## Commentary on the Town Centre Improvements proposed by Babergh DC and SCC Highways

The  
Sudbury  
Society

15 August 2022

## Market Hill, parking

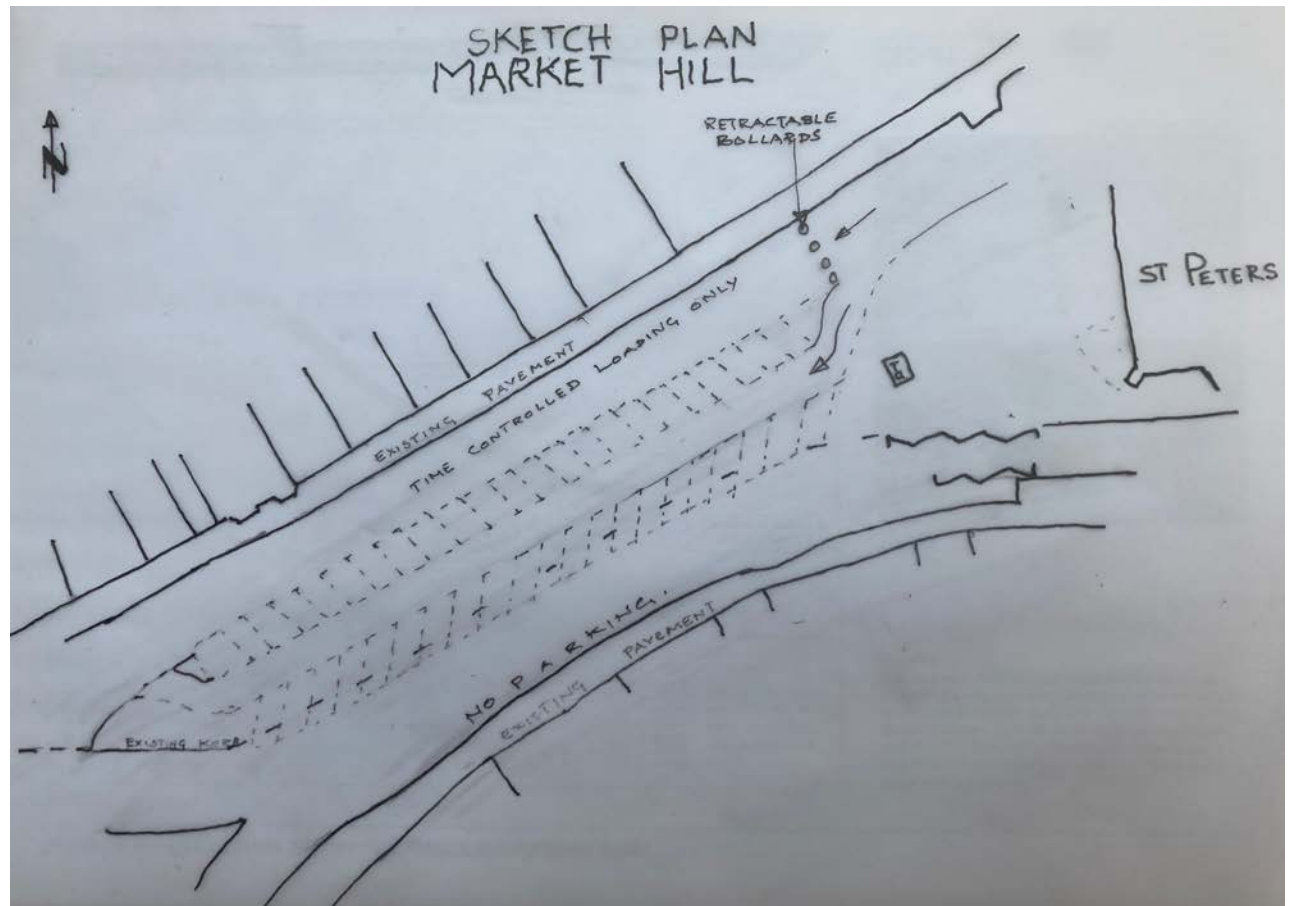
There are at present c.76 parking spaces on Market Hill, 42 in the central two rows, 17 on the north side and 17 on the south side. We welcome the proposals to reduce this but we oppose any drastic reductions which will do lasting damage to town centre trade.

The sketch shows how Market Hill could continue to accommodate two rows of parked vehicles (total 42) with an access road between them. At present, drivers entering and backing out from the outer row of spaces cause obstructions. In this sketch, traffic access to parking spaces is from behind St Peter's only.

The outer verge of the parking area would move southwards a few feet to accommodate this plan. This would require the removal of parking along Market Hill south side, retaining 7-8 spaces further to the south east on King Street, some of which can be for blue badge holders. The result will be total of c.50 spaces, a reduction by a third.

We advocate a semi-permanent 'high hedge' of planters with more substantial planting to separate parked cars from the A131 through road, with gaps between them for pedestrian access. Planters should contain non-seasonal taller shrubs to provide a screen against traffic noise and pollution.
